# Question 8: Emissions sources

## Pre-synthesis

Global BC Emissions by Region

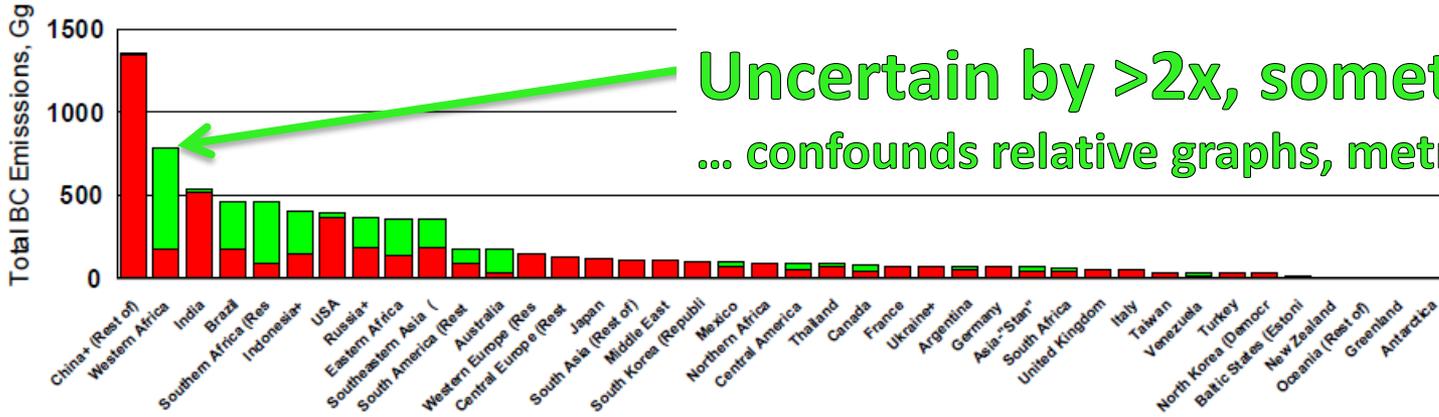
Uncertain by >2x, sometimes >>2x  
 ... confounds relative graphs, metrics, conclusions
